PARTS & SERVICE NEWS

REF NO.	AT02074
DATE	Jul. 11, 2002

SUBJECT: REPAIR PROCEDURE OF ENGINE WIRING HARNESS CLAMP ON WA1200-3

PURPOSE: To introduce modification procedure to prevent occurrence of engine harness clamp trouble on WA1200-3 wheel loaders

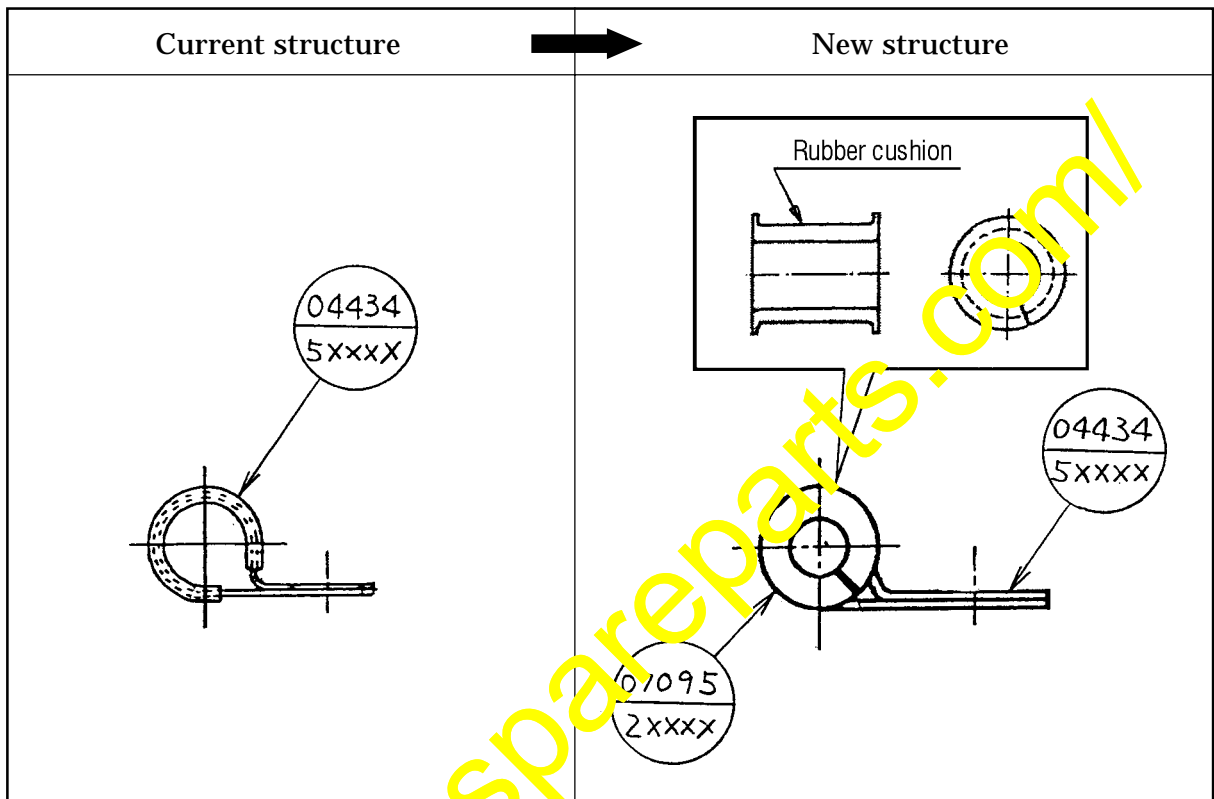
Since the clamped sections of the engine wiring harness on the WA1200-3 wheel loaders may wear by vibrations of the machine and the engine wiring harness may be damaged, implement the modification being introduced in this Service News to prevent occurrence of the aforementioned damage of the engine wiring harness.

The size of the clamp has been reviewed and, at the same time, the clamp has been changed to rubber cushioned clamp to eliminate the backlash between the harness and the clamp thus preventing occurrence of wears of the clamped section by vibrations of the machine.

Replace the clamp following the instructions as per the drawing below.

If the harness (marked ※) is damaged, replace it also.

Bundle the excessive section of the harness and fasten the section with bands.
